0.0 Planning Permit Application PLN18/0336 at 107-111 Andersons Creek Road, Doncaster East for buildings and works for the construction of 52 independent living units associated with the existing retirement village

File Number: IN18/534
Responsible Director:
Applicant: Baptcare Ltd c/- Urbis
Planning Controls: General Residential Zone – Schedule 3
Ward: Mullum Mullum
Attachments: 1 Attachment 1- Decision Plans PLN18/0336
2 Attachment 2 Legislative Requirements PLN18/0336

Figure 2 – The proposed development in Stages.

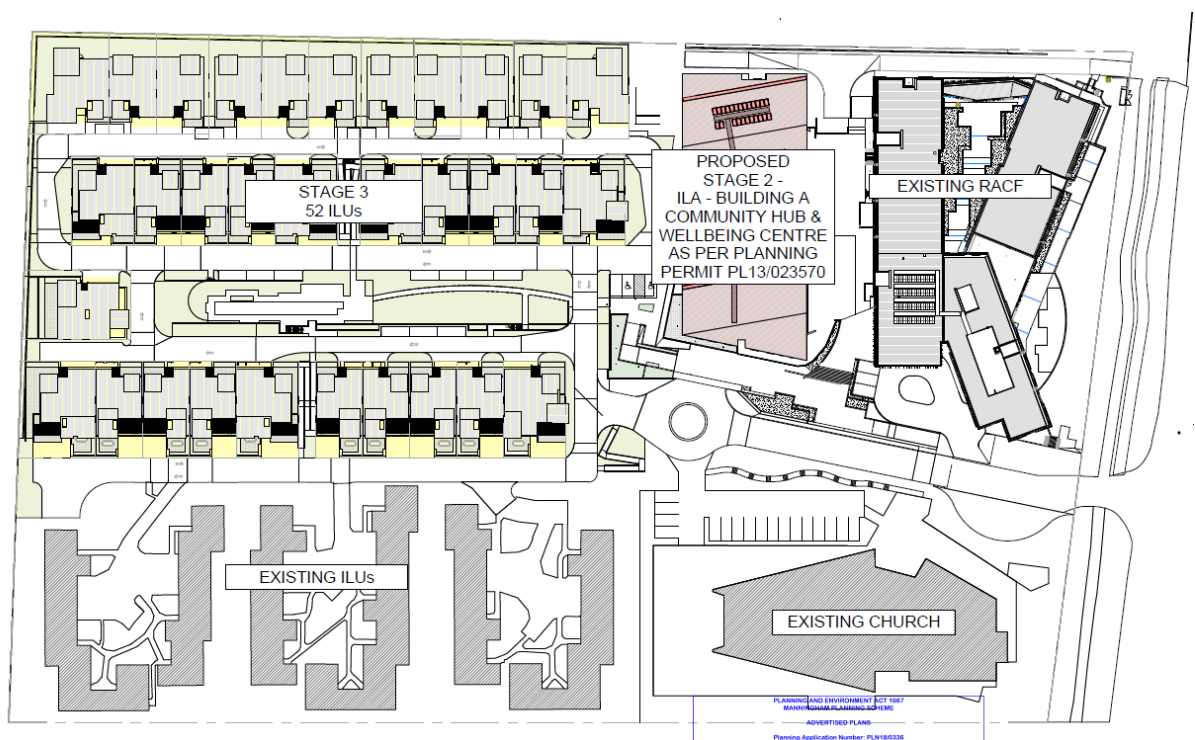
4.4 This application essentially replaces Stage 3 from the approved development under Planning Permit PL13/022570 (the three four-storey retirement apartments) with Independent Living Units (ILU). The dwelling yield reduces as a consequence from 94 apartments to 52 units. The new staging is shown in Figure 2.
